कार्यालय
प्रभागीय वनाधिकारी, अल्मोड़ा वन प्रभाग, अल्मोड़ा

विषय बयेला नाड़ मोटर मार्ग के वन भूमि हस्तान्तरण के संबन्ध में।(प्रस्ताव सं० 9364/2015)

विषय :- बयेड़ा-नाड़ मोटर मार्ग के वन भूमि हस्तान्तरण के सम्बन्ध में।
(प्रस्ताव सं. 9364/2015)

जियोस्फेरिक्स मैप :- बघेला नाड मोटर मार्ग का नव निर्माण के क्षतिपूरक हेतु चयनित स्थल फलादाटी सिविला

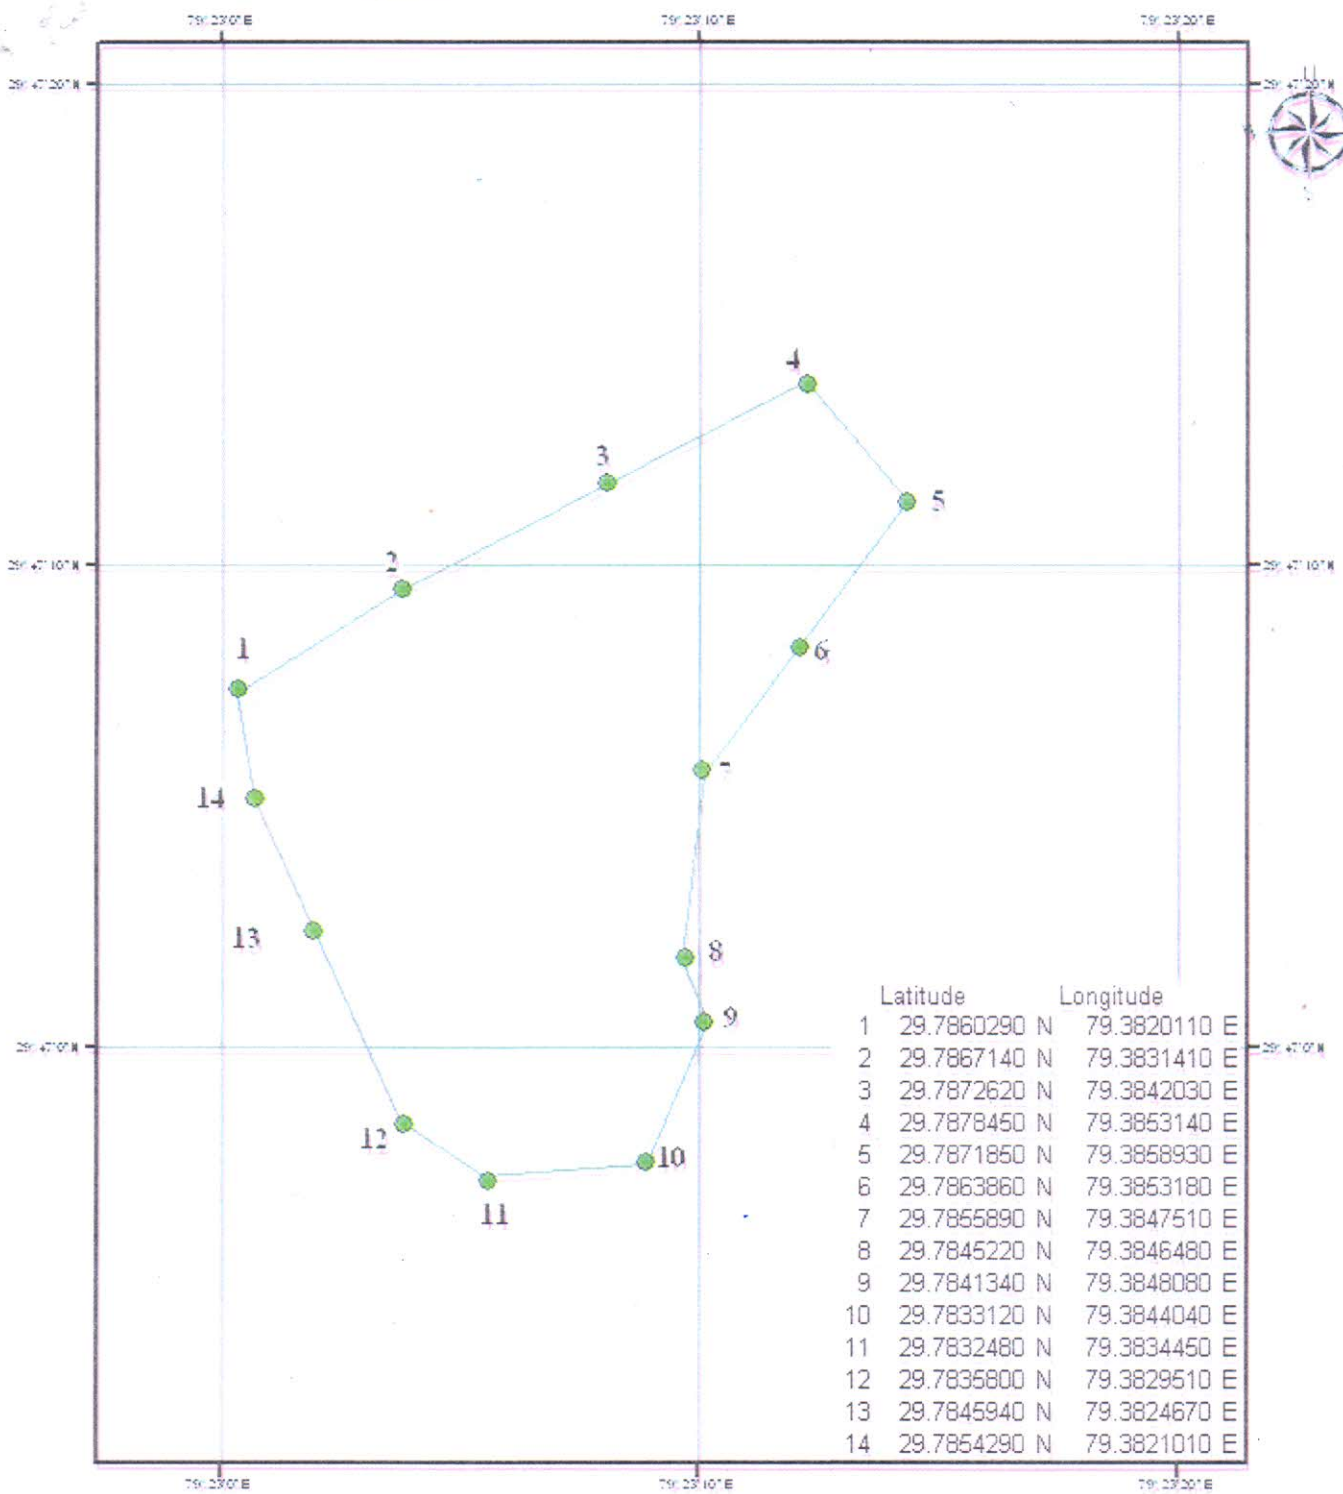
1	The DSS analysis the area calculated as 6.39 ha instead of 8.828ha area proposed for CA in Phaldwari civil. The state Govt may revise the KML on exact to the scale for area 8.828ha and upload the same in online Part-1	The correct analysis the area calculated as 8.828ha. Parposed for CA in Phaldwari. The KML file uploaded in on line Part-I Para-C
2	The area marked for muck dumping in private land the details may also provide in the component wise break up in online Part-I	The area marked for muck dumping in provate land. The component wise break up in on line part-I Para 2.4
3	The Digital map of area proposed for CA is provided with three coordinates while the shape of the area requires coordinates of few more corners. The state Govt. may provide few more coordinates in the map and upload the revised may in this place in online Part-I	The Revised Digital map of area proposed for CA is 14 corner coordinates is attached in on line part-1 Para-C
